Land to the rear of 74 Hookhams Lane,  
Renhold

Technical Note- Response to Highway  
Authority Comments

December 2019

REPORT TITLE:	<b>TECHNICAL NOTE- RESPONSE TO HIGHWAYS COMMENTS</b>		
PREPARED BY:	[REDACTED]	DATE:	<b>DECEMBER 2019</b>
CHECKED BY:	[REDACTED]	DATE:	<b>DECEMBER 2019</b>

**TITLE:** Swept Path Analysis  
Refuse Vehicle

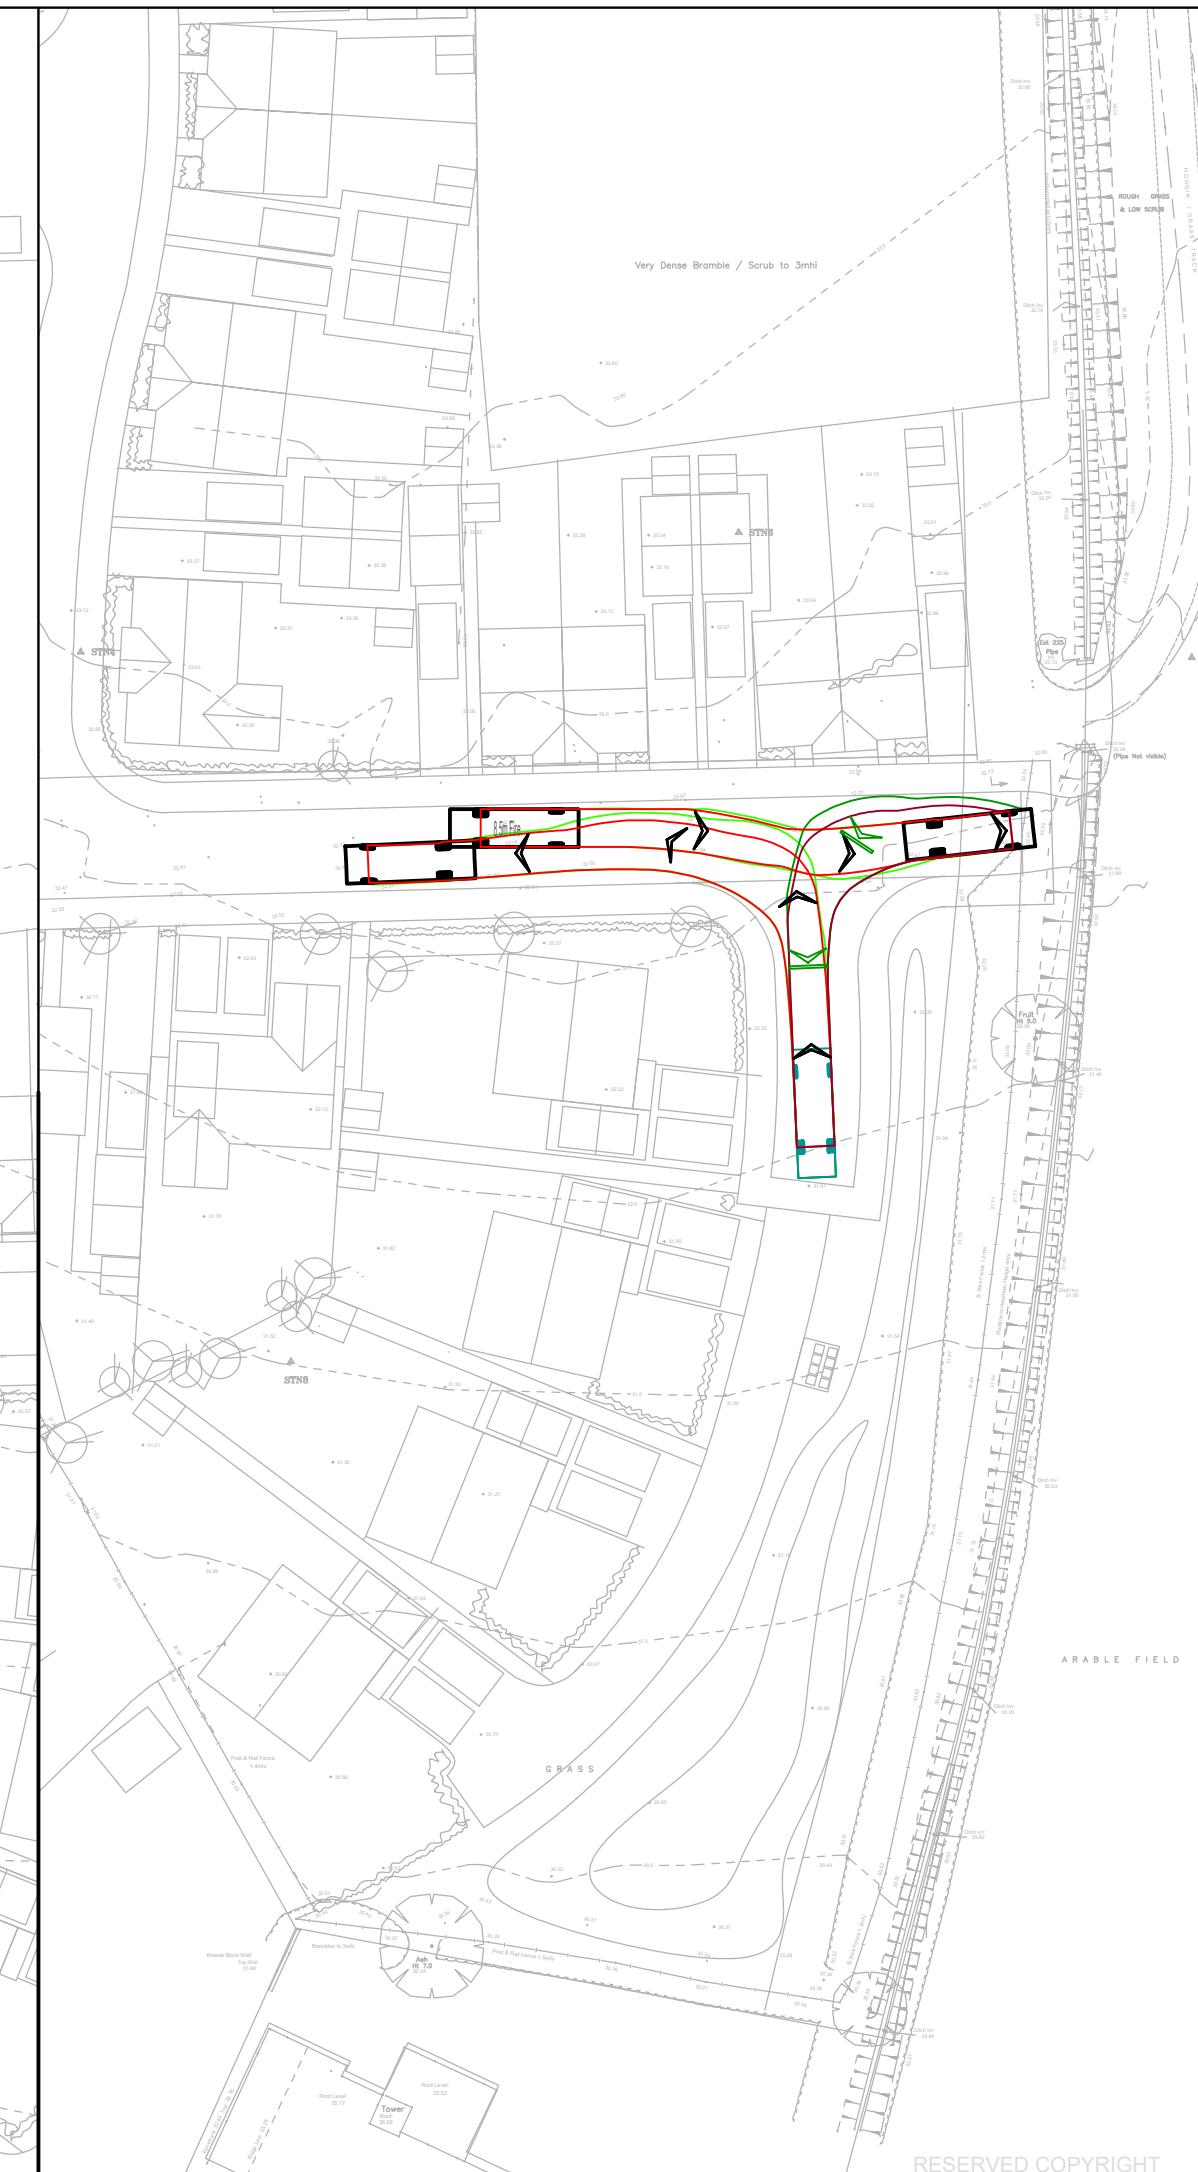
**The refuse truck must be able to turn within the highway. It appears that a refuse truck would need to turn into the parking area by P27/P26 and into the private drive by P17.**

- 2.21 Swept path analysis of the BBC refuse vehicle has been undertaken of the revised layout, and is contained at **Appendix D**. This demonstrates that a refuse vehicle can satisfactorily turn within the parking area between plots 24-25 and 26-27, and also within the junction adjacent to Plot 17. A bin collection point is then provided for Plots 17-20 so that the refuse vehicle does not need to enter the private drive.

TITLE:  
Swept Path Analysis  
Fire Tender

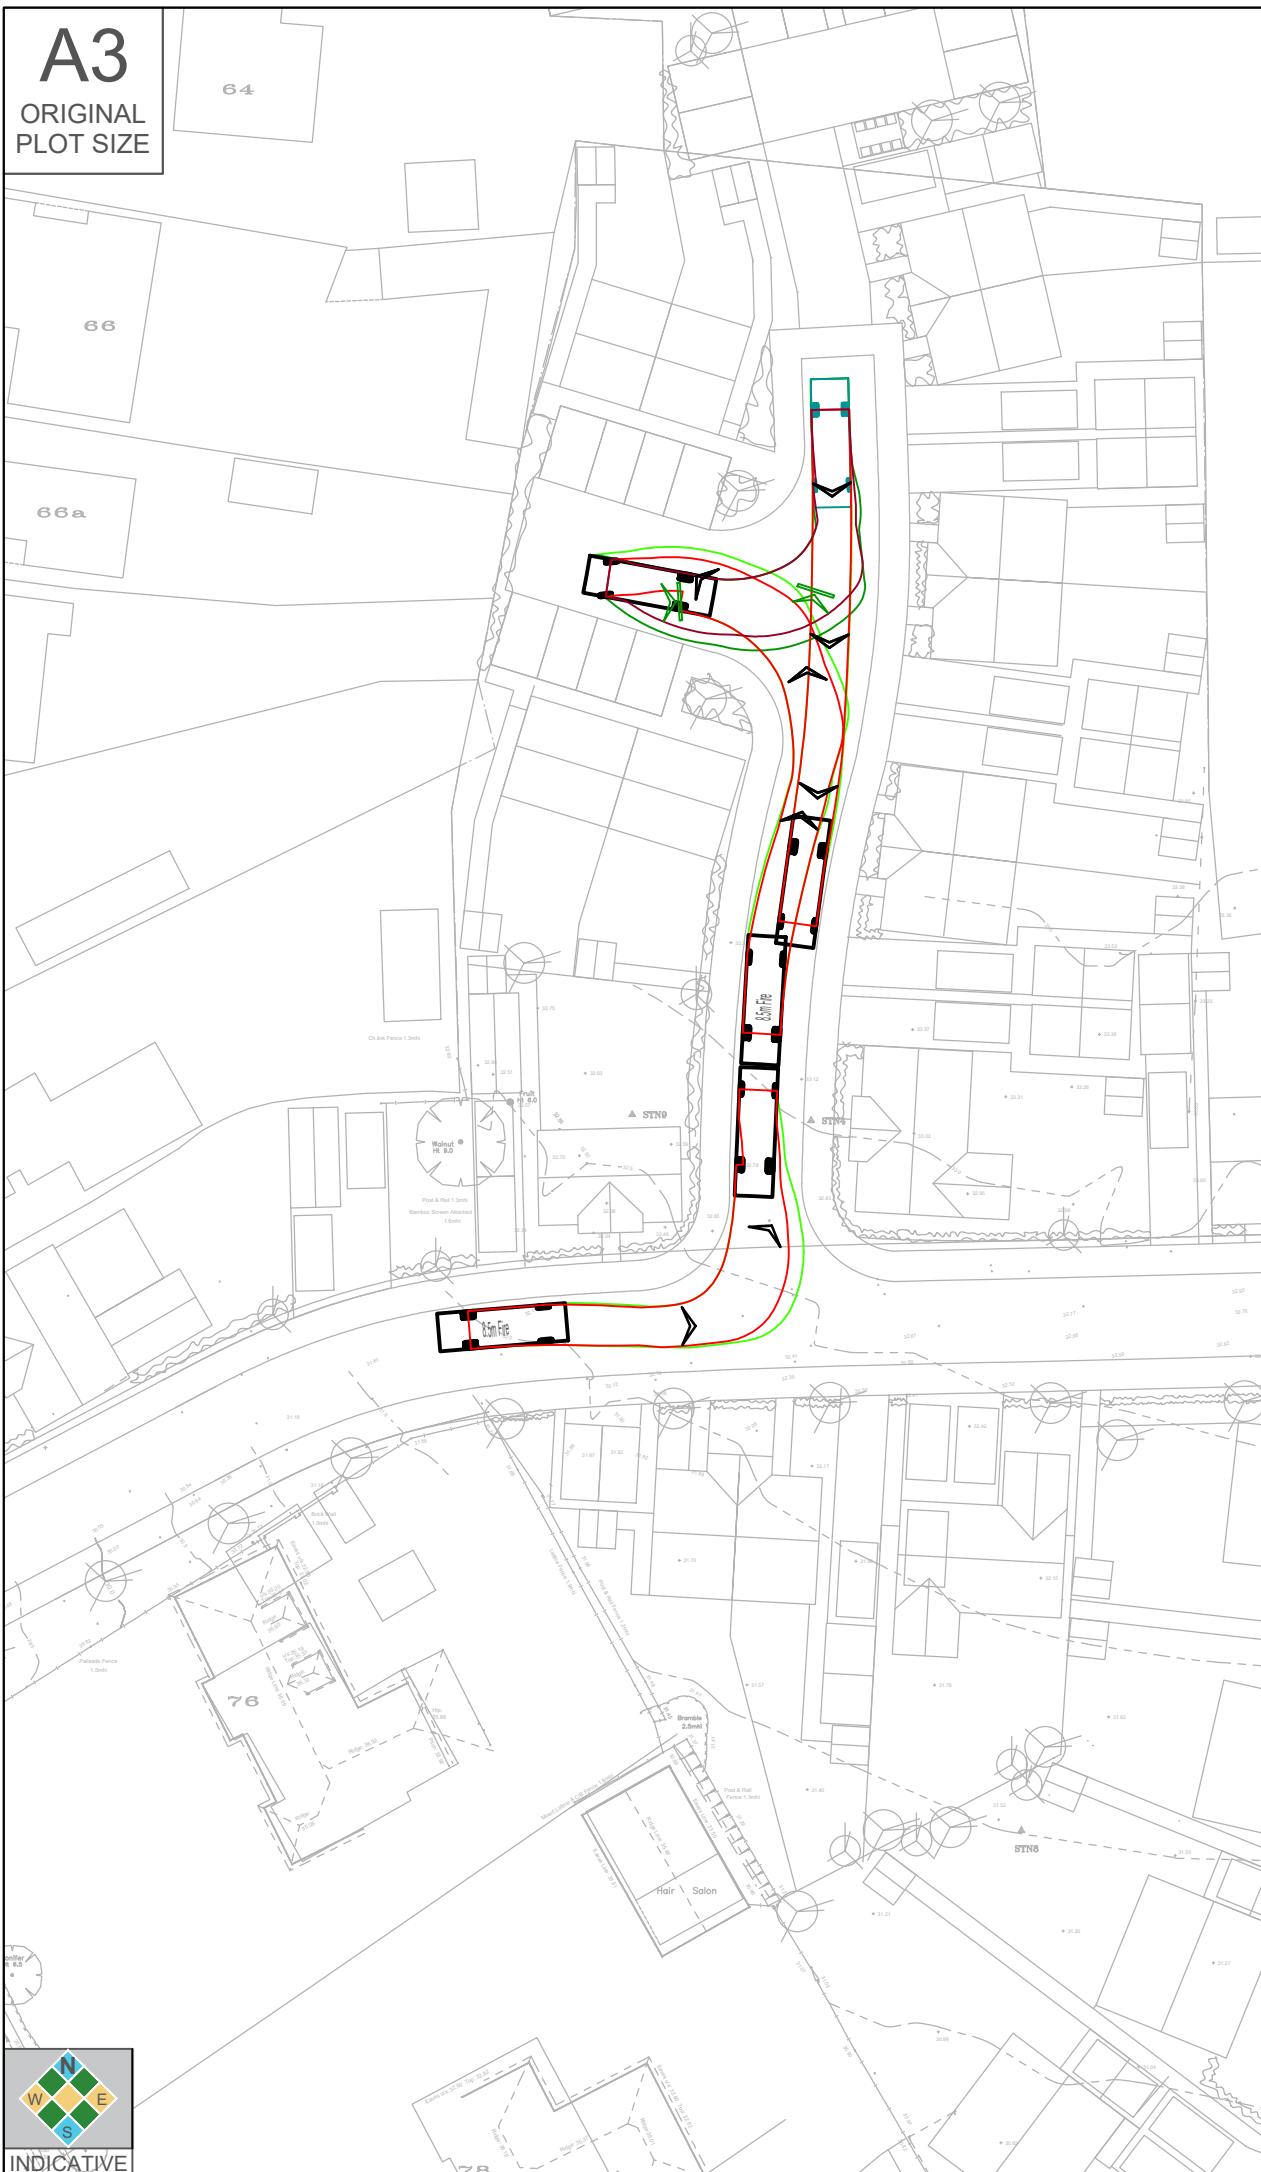
**A fire truck will only reverse from a private drive for 20M and all parts of each dwelling need to be within 45M for fire hoses. Therefore P20 is too far away for a fire engine to reach unless a turning point is included within the private drive.**

- 2.22 Swept path analysis of a Bedfordshire fire tender has been undertaken as is also provided at **Appendix D**. This demonstrates that the vehicle can reverse 20m, without entering the private drive. All dwelling entrances are within 45m, however for any dwellings that are not within 45m, domestic residential sprinklers can be installed in accordance with Bedfordshire Fire & Rescue Service policy.
